WATTS BAR NUCLEAR PLANT (WBN) UNIT 1 - AMERICAN SOCIETY OF
MECHANICAL ENGINEERS (ASME) SECTION XI INSERVICE PRESSURE
TESTING PROGRAM REQUEST FOR RELIEF ISPT-09 (TAC NO. MC8305)

WATTS BAR NUCLEAR PLANT (WBN) UNIT 1
AMERICAN SOCIETY OF MECHANICAL ENGINEERS (ASME) SECTION XI
REQUEST FOR RELIEF ISPT-09
RESPONSE TO REQUEST FOR ADDITIONAL INFORMATION

TVA DWG NO. 1-47W811-1 R42
FIGURE 6.3-1 SH 1

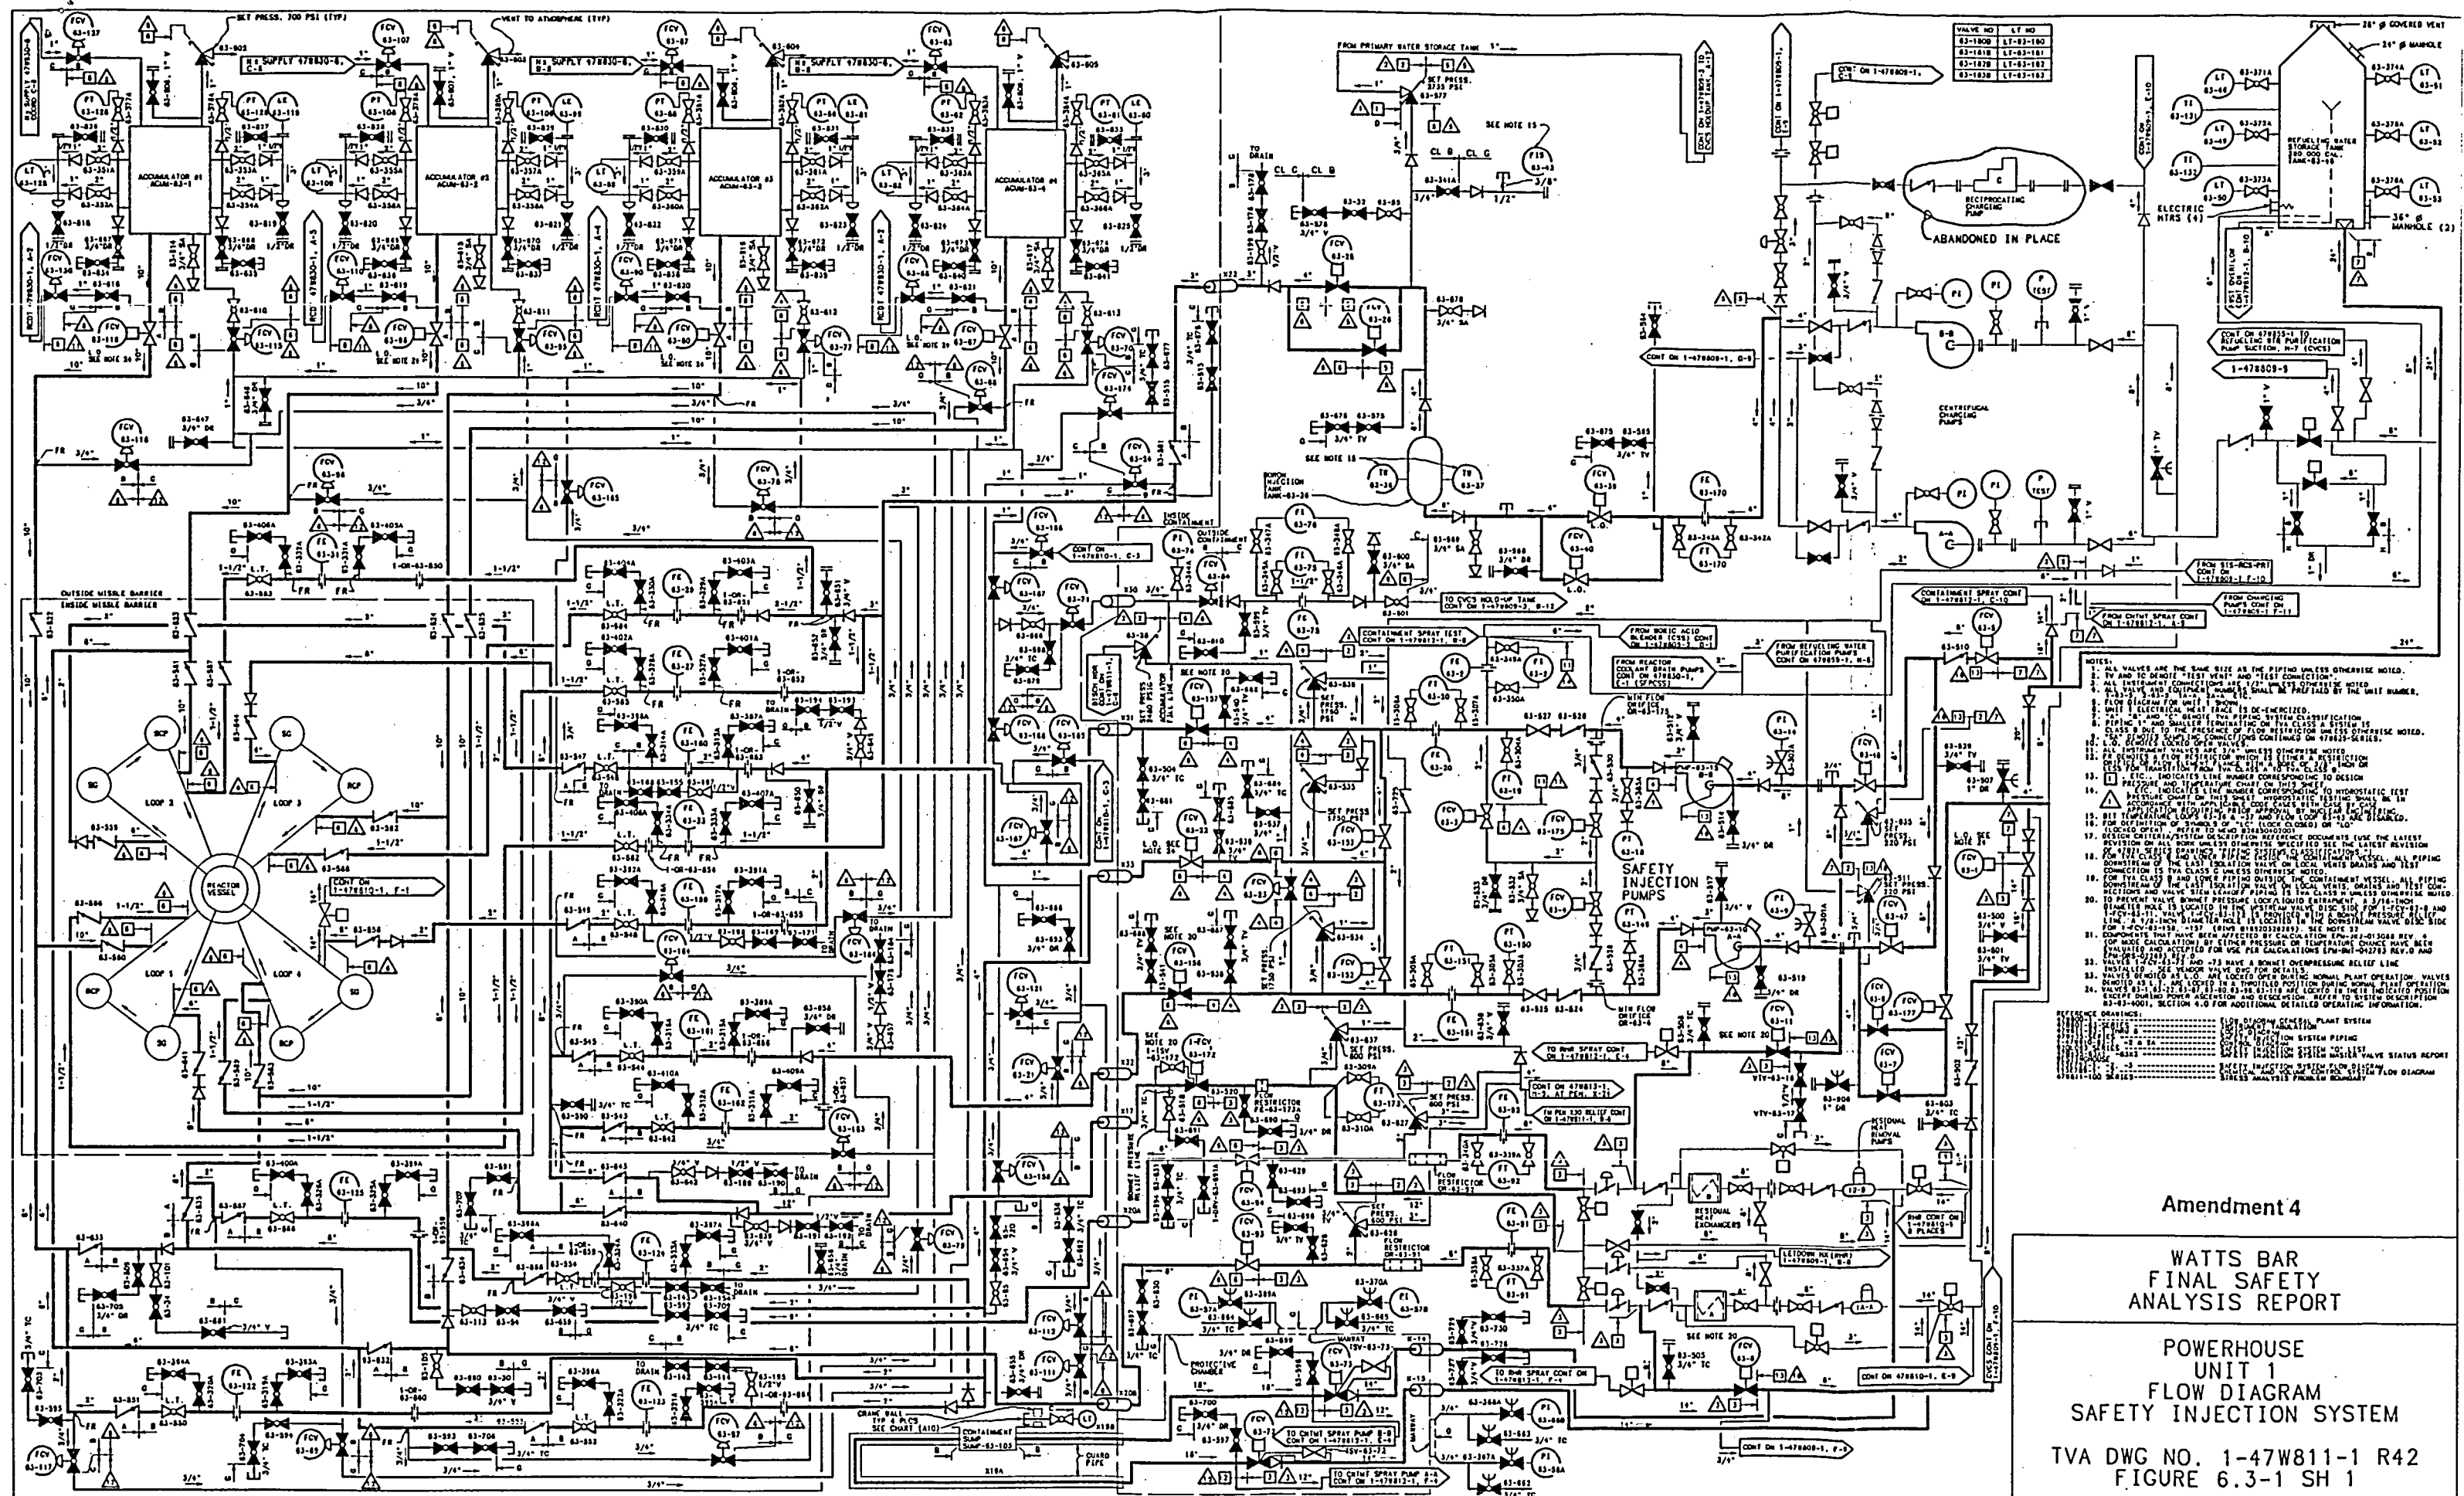
- a. Reactor Coolant Loop 1 on Page E-7: "Low pressure safety injection from RHR system CKV-63-633 to the 10-inch Loop 1 cold leg injection line." Clarify which component in the 10-inch Loop 1 cold leg injection line bounds the end of the piping segment that requires pressure testing.

- c. *Reactor Coolant Loop 1 on Page E-7: "Safety injection pump piping from CKV-63-543 to the 8-inch Loop 1 hot leg injection line." Clarify which component in the 8-inch Loop 1 hot leg injection line bounds the end of the piping segment.*

- d. *Reactor Coolant Loop 1 on Page E-7: "Safety injection pump piping from CKV-63-551 to the 6-inch Loop 1 cold leg injection line." Clarify which component in the 6-inch Loop*

- i. *Reactor Coolant Loop 3 on Page E-9: "Low pressure safety injection from RHR system CKV-63-634 to the 10-inch Loop 3 cold leg injection line." Clarify which component in the 10-inch Loop 3 cold leg injection line bounds the end of the piping segment.*

- k. **Reactor Coolant Loop 3 on Page E-9: "Safety injection pump piping from CKV-63-545 to the 8-inch Loop 3 hot leg injection line." Clarify which component in the 8-inch Loop 3 hot leg injection line bounds the end of the piping segment.**

- l. **Reactor Coolant Loop 3 on Page E-9: "Safety injection pump piping from CKV-63-555 to the 6-inch Loop 3 cold leg injection line." Clarify which component in the 6-inch Loop 3 cold leg injection line bounds the end of the piping segment.**

The 10-inch Loop 1 cold leg injection line adjoined by this 6-inch branch connection is the second item in the listing of Loop 1 pipe segments and is bounded by CKV-63-622 and CKV-63-560. This 6-inch branch connection begins at outboard check valve CKV-63-633 and continues inboard to the point where it joins the 10-inch Loop 1 cold leg injection line.

The 8-inch Loop 1 hot leg line adjoined by this 2-inch branch connection is the last piping segment in the listing of Loop 1 piping segments and is bounded by CKV-63-640 and CKV-63-641. This 2-inch branch connection begins at outboard check valve CKV-63-543 and continues inboard to the point where it joins the 8-inch residual heat removal (RHR) hot leg injection piping.

The 6-inch Loop 1 cold leg injection line is the third item down in the Loop 1 grouping of pipe segments and is bounded by CKV-63-633. The 6-inch Loop 1 cold leg injection line, which is discussed in Item 4.a of this request, connects to the 10-inch cold leg accumulator (CLA) 1 discharge line that is the second item down in the Loop 1 grouping of pipe segments and is bounded by CKV-63-622 and CKV-63-560. The segment discussed in this item is a 2-inch branch connection beginning at outboard check valve, CKV-63-0551, and continuing inboard to the point where it joins the 6-inch Loop 1 cold leg injection line.

The 10-inch Loop 3 cold leg injection line adjoined is the second item in the listing of Loop 3 pipe segments and is bounded by CKV-63-624 and CKV-63-562. This piping segment is a 6-inch branch connection beginning at outboard check valve CKV-63-634 and continuing inboard to the point where it joins the 10-inch Loop 3 cold leg injection line.

The 8-inch Loop 3 hot leg injection line adjoined is the last piping segment in the listing of Loop 3 piping segments and is bounded by CKV-63-643 and CKV-63-644. This segment of piping is a 2-inch branch connection beginning at outboard check valve CKV-63-545 and continuing inboard to the point where it joins the 8-inch Loop 3 hot leg injection line.

The 6-inch Loop 3 cold leg injection line is the third item down in the Loop 3 grouping of pipe segments and is bounded by CKV-63-634. It is also discussed in Item 4.i of this response. The 6-inch Loop 3 cold leg injection line connects to the 10-inch CLA 3 discharge line bounded by CKV-63-624 and CKV-63-562. The 10-inch CLA 3 discharge line is the second item down in the Loop 3 grouping of pipe segments. The piping segment addressed by this item is a 2-inch branch connection beginning at outboard check valve CKV-63-555 and continuing inboard to the point where it joins the 6-inch Loop 3 cold leg injection line.
